METROPOLITAN GOVERNMENT OF NASHVILLE AND DAVIDSON COUNTY

STAFF RECOMMENDATION 2206 Belmont Boulevard August 21, 2019

Application: New Construction—Addition and Outbuilding; Demolition—Outbuilding; Partial Demolition

District: Belmont-Hillsboro Neighborhood Conservation Zoning Overlay

Figure 2. The existing outbuilding, as seen from the alley.

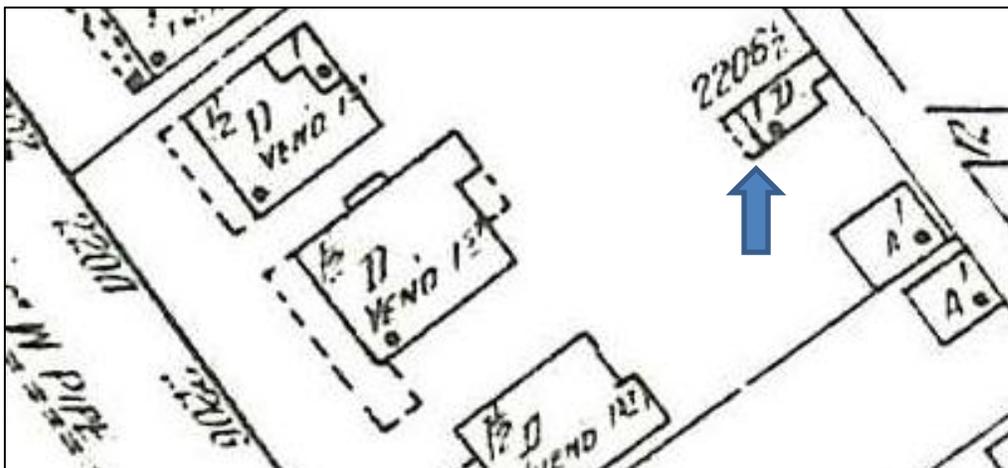
Demolition: The applicant is proposing to demolish an existing outbuilding (Figure 2). The date of construction of the outbuilding is not known, and it is possible that the structure is the same structure marked as a dwelling on the 1951 and 1957 Sanborn Maps (Figure 3). Nevertheless, staff finds that the outbuilding's location all the way at the back of the lot and its utilitarian design does not contribute to the historic character of the house. Staff therefore finds that its demolition meets the design guidelines.

A2.11

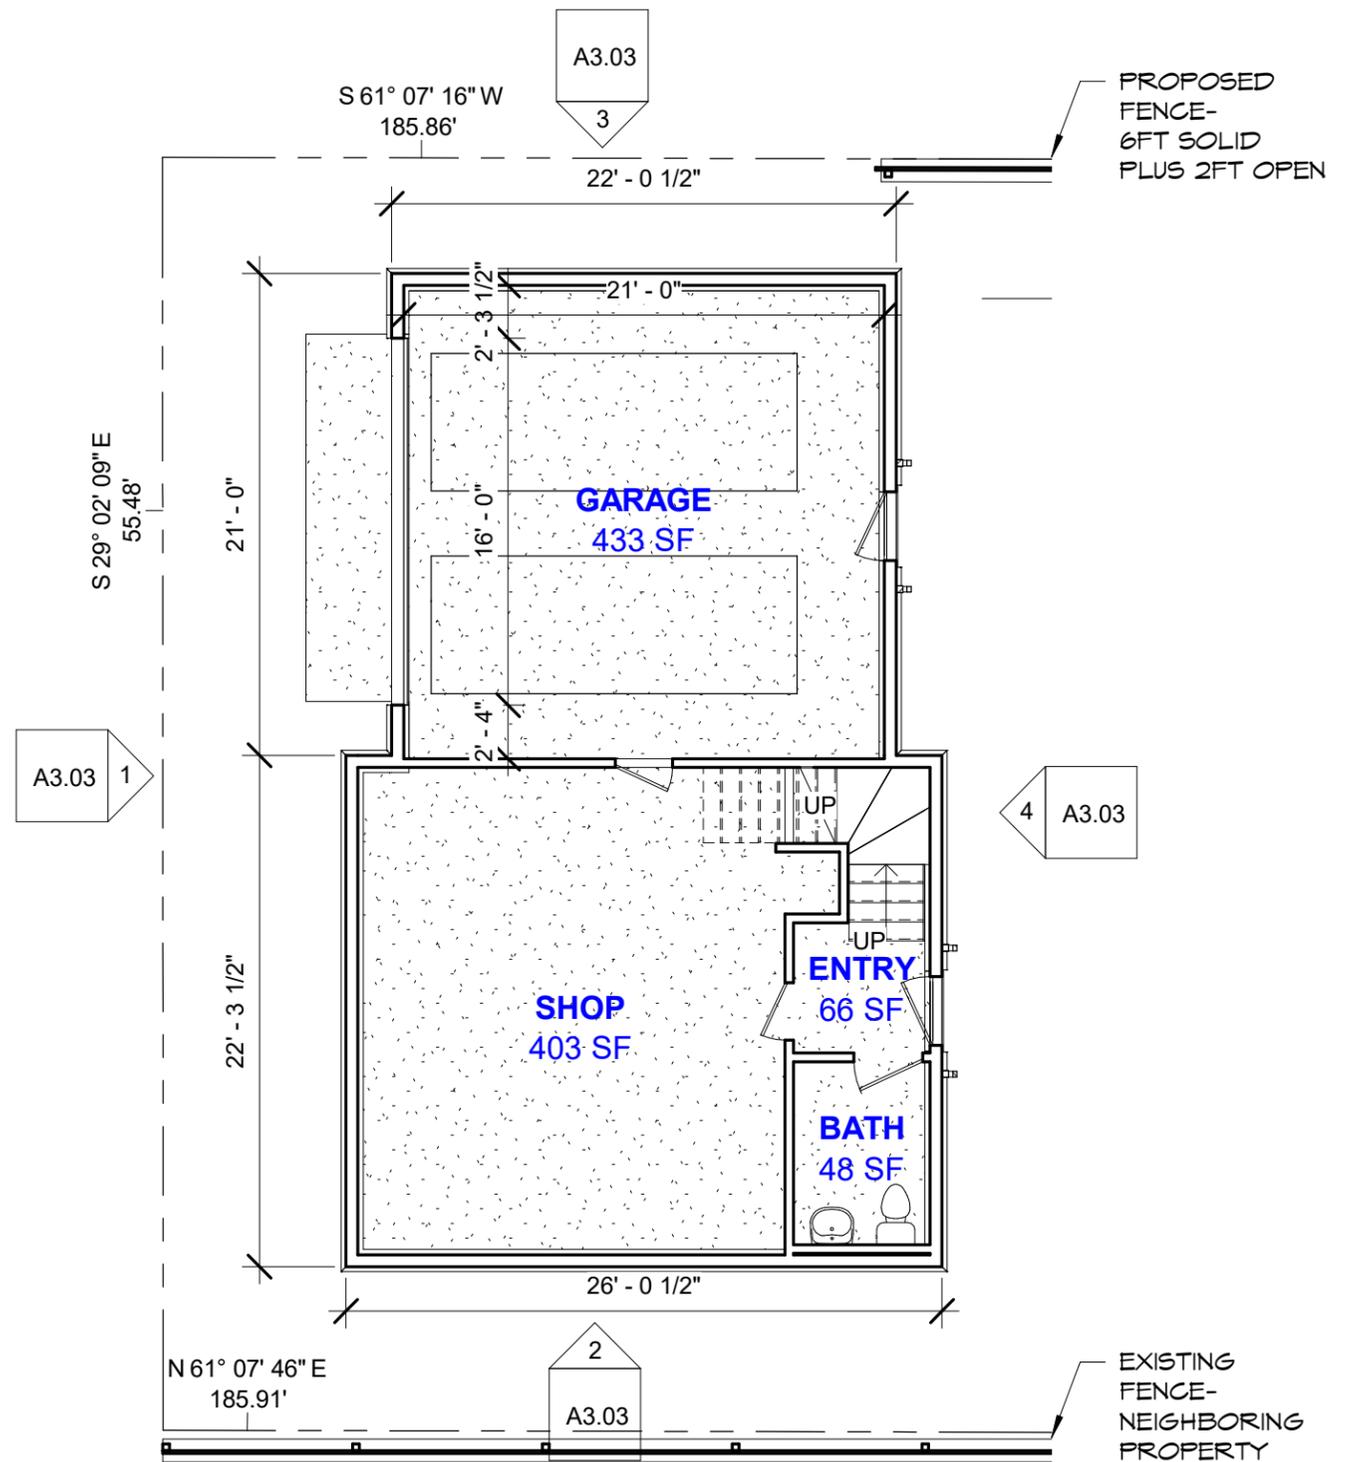
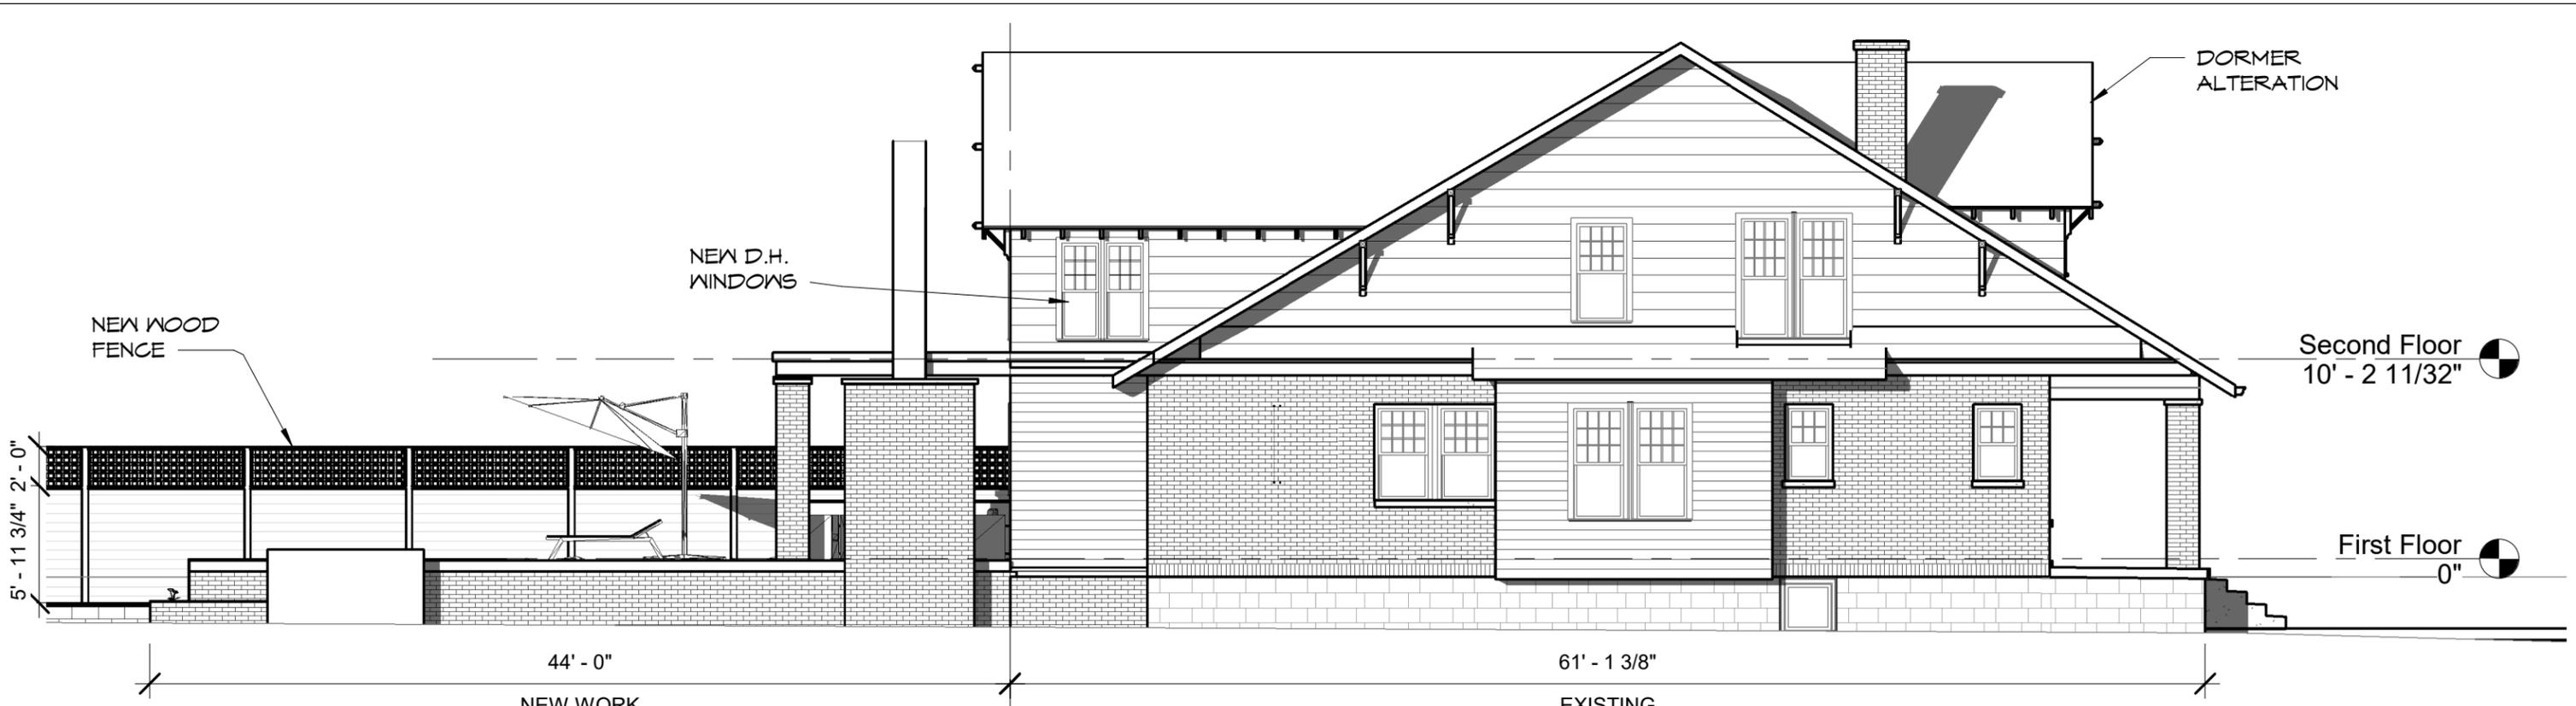
*The design guidelines limit outbuildings to 1,000 sq. ft. on lots of this size. The applicant is proposing an outbuilding that has a larger footprint of one thousand and forty square feet. Staff recommends that the outbuilding’s footprint be reduced to be no larger than 1,000 sq. ft.

** The proposed outbuilding has an eave height ranging from twelve feet, six inches to fourteen feet (12’6”-14’). The design guidelines limit the eave height of outbuildings behind one-and-a-half story houses to ten feet (10’). Staff therefore recommends that the eave heights be reduced to be no taller than ten feet (10’).

In summary, staff recommends approval of the outbuilding with the conditions that the footprint be no larger than 1,000 sq. ft., the eave height be no taller than ten feet (10'), and staff approval all final material choices.

Building Elevations		A3.00
Date	Aug. 1, 2019	
Scale	1/8" = 1'-0"

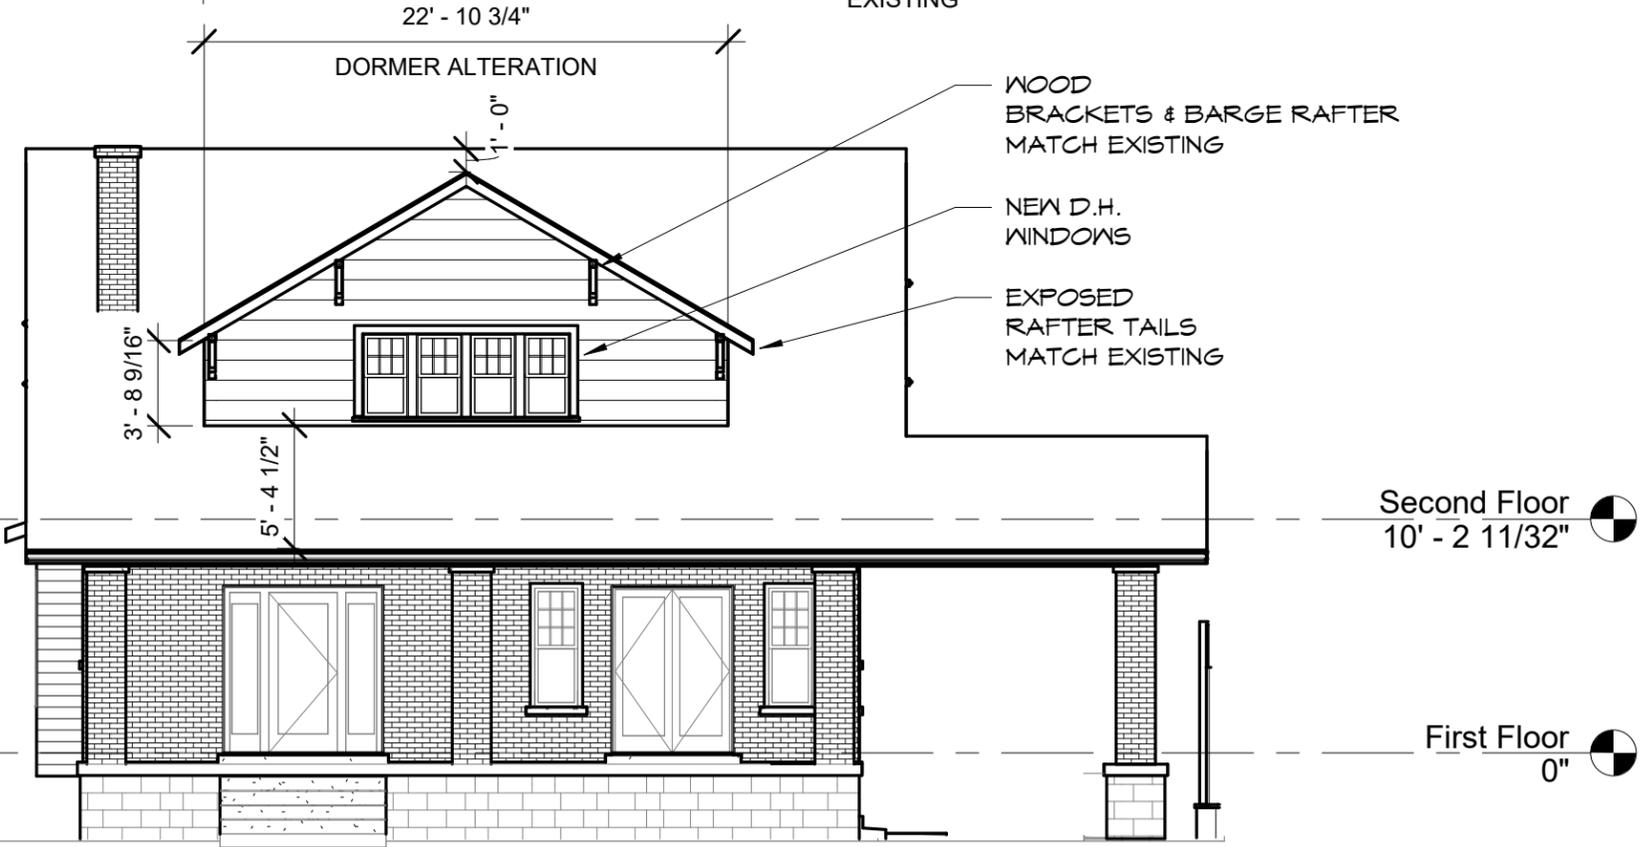
On the front façade, the applicant is proposing to remove the two front dormers so that a larger front dormer can be constructed (Figure 5). There is no evidence that these two dormers are not original to the house, and it is highly likely that they are original features. They appear in the c.1968 Property Assessor photo (Figure 6). Front dormers like these are an integral part of a historic bungalow’s design and character. Bungalow front dormers come in all shape, sizes, and locations, and are defining features of these houses. The design guidelines do not allow for the removal of character-defining features like front dormers.

Furthermore, by state law, all design guidelines for historic and conservation zoning overlays must meet the Secretary of Interior Standards for Historic Preservation. The standards state, “The removal of historic materials or alteration of features and spaces that characterize a property shall be avoided.” They further explain, “New additions, exterior alterations, or related new construction shall not destroy historic materials that characterize the property.” The removal of the historic front dormers so that a larger front dormer can be created meets neither the design guidelines nor the Secretary of Interior Standards. Staff recommends that the front dormers remain as they are now.

Height & Scale: The applicant is proposing to construct a new front dormer. While the dormer's height and scale could be appropriate if it were built on an infill house, the dormer is not appropriate on the front of this historic house because it requires the demolition of the existing, historic front dormers. It adds a conjectural element to the front façade – i.e. a new dormer design that never existed on this house.

1. The front dormers remain unchanged and no new front dormer be constructed;
2. The outbuilding's footprint be no larger than 1,000 sq. ft.;
3. The outbuilding's eave height be no taller than ten feet (10');
4. Staff approve all window and door selections;
5. Staff approve the roof shingle color and texture;
6. Staff approve a brick sample; and
7. The HVAC and utility connections be located on the rear or behind the midpoint of the house.

A3.03

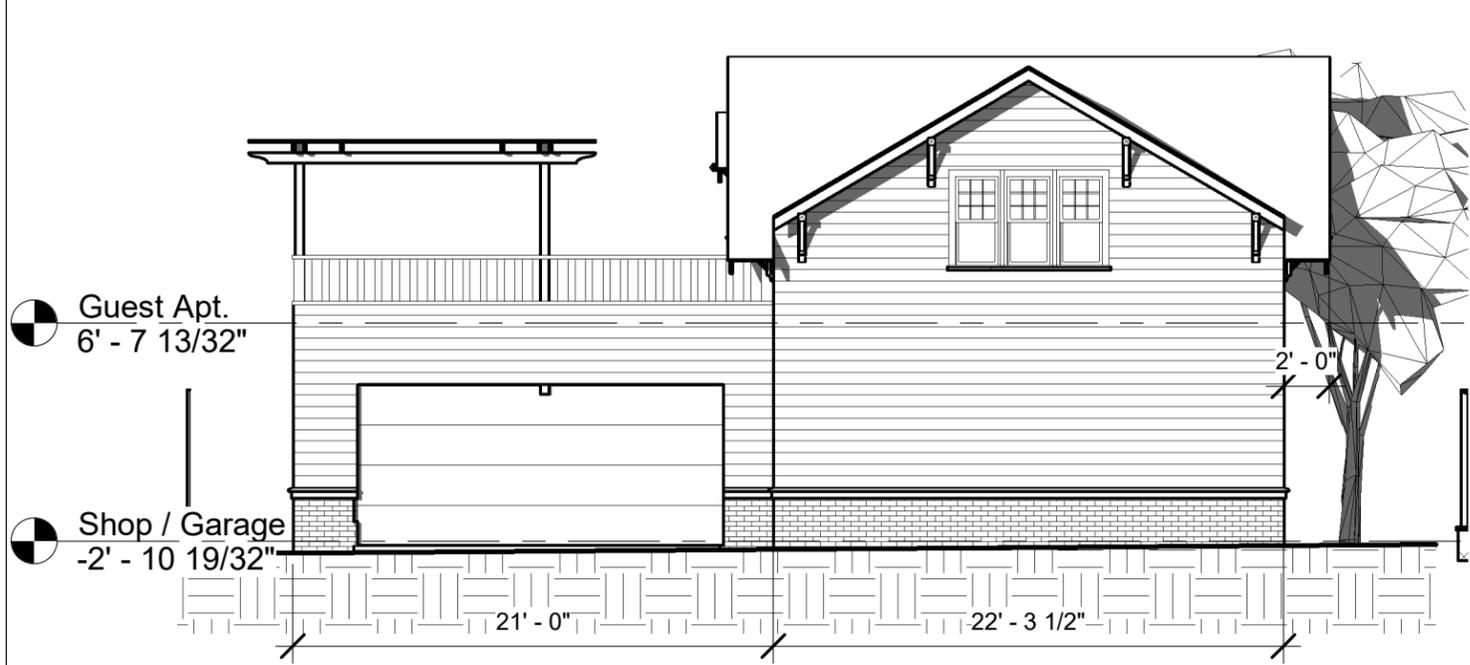
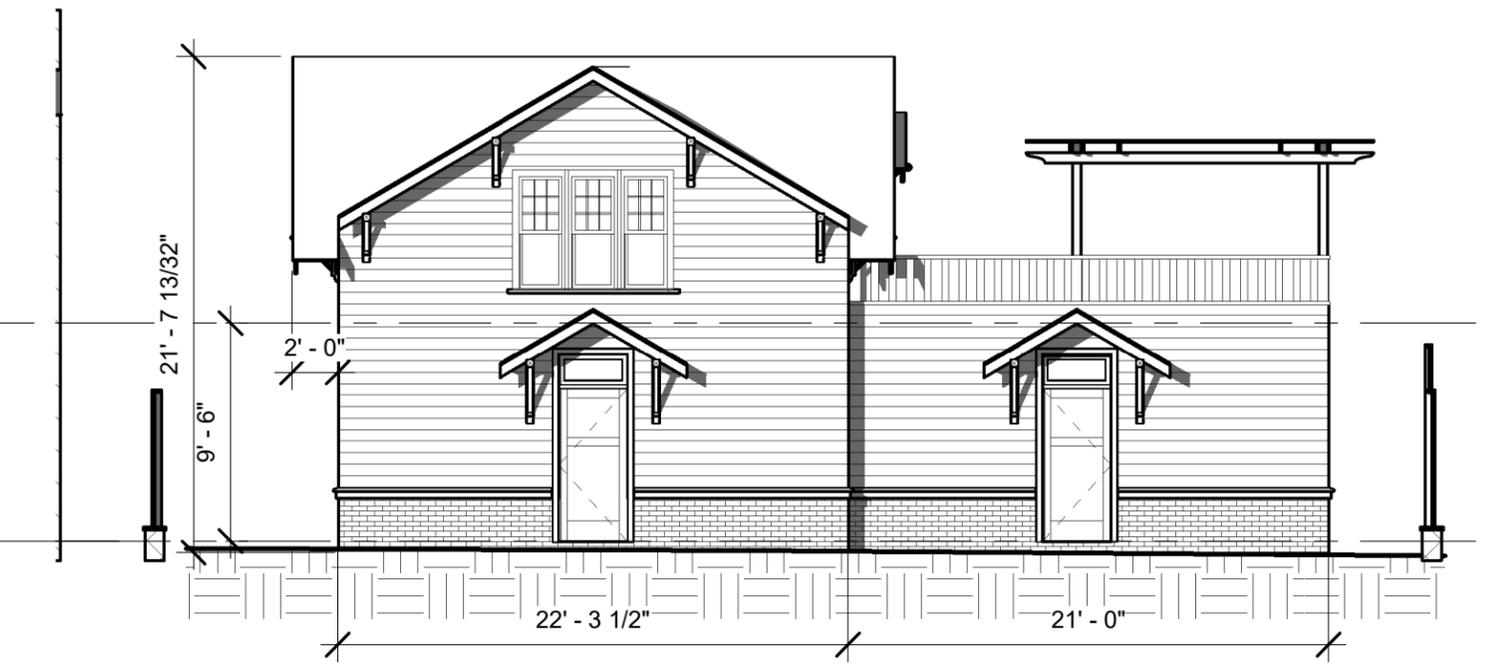
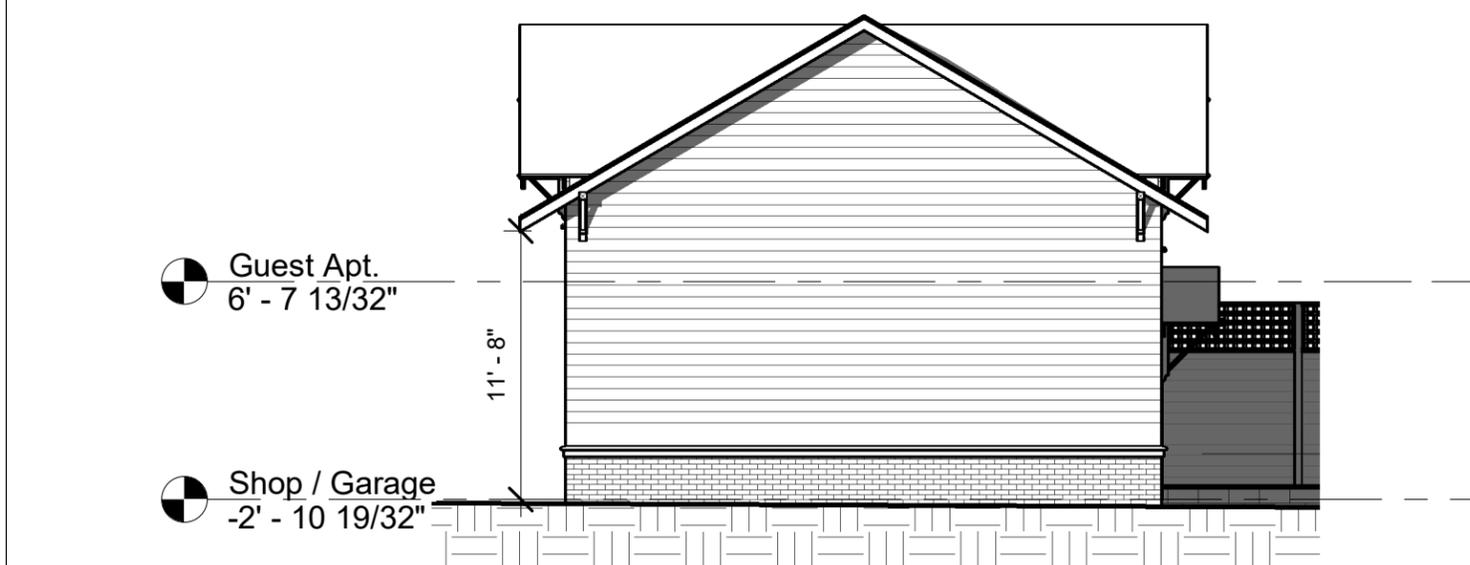
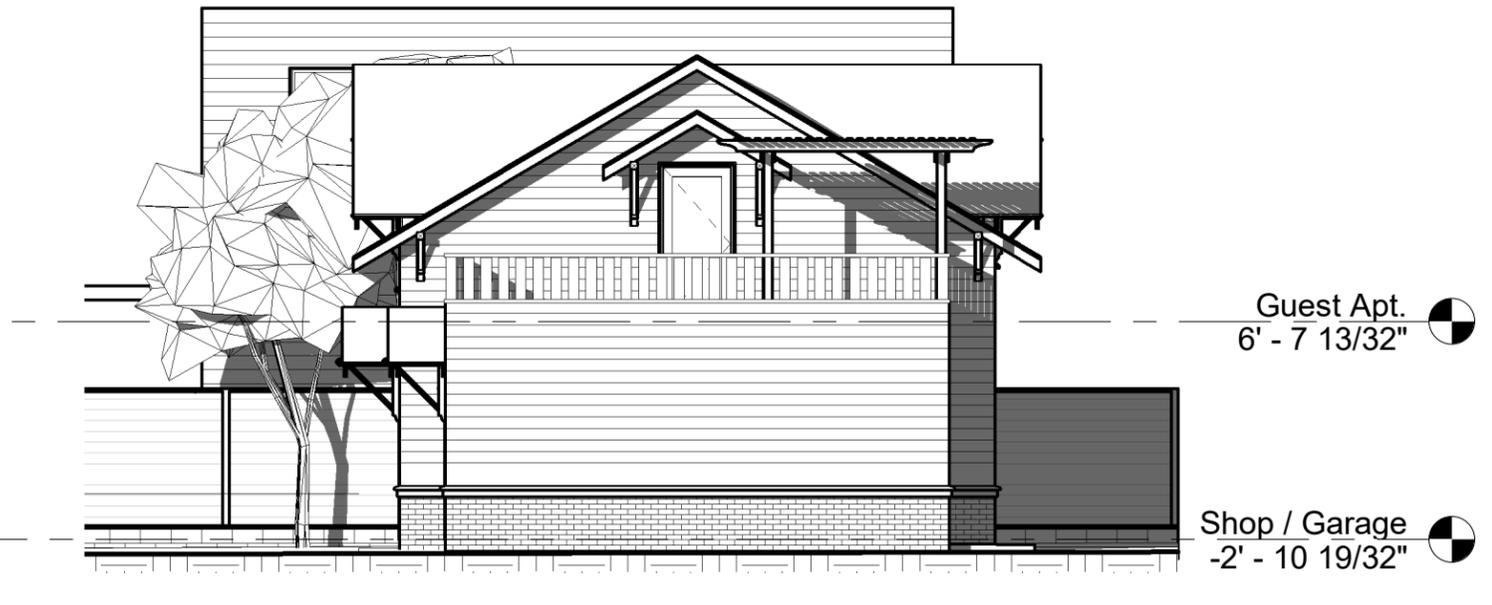
The outbuilding has two parts—a one-and-a-half story, cross-gable portion and a one-story, flat roof portion. Staff finds that the two roof forms are appropriate for an outbuilding. With the condition that the eave height be no taller than ten feet (10’), staff finds that the roof forms meet Section II.B.1.i.1 of the design guidelines.
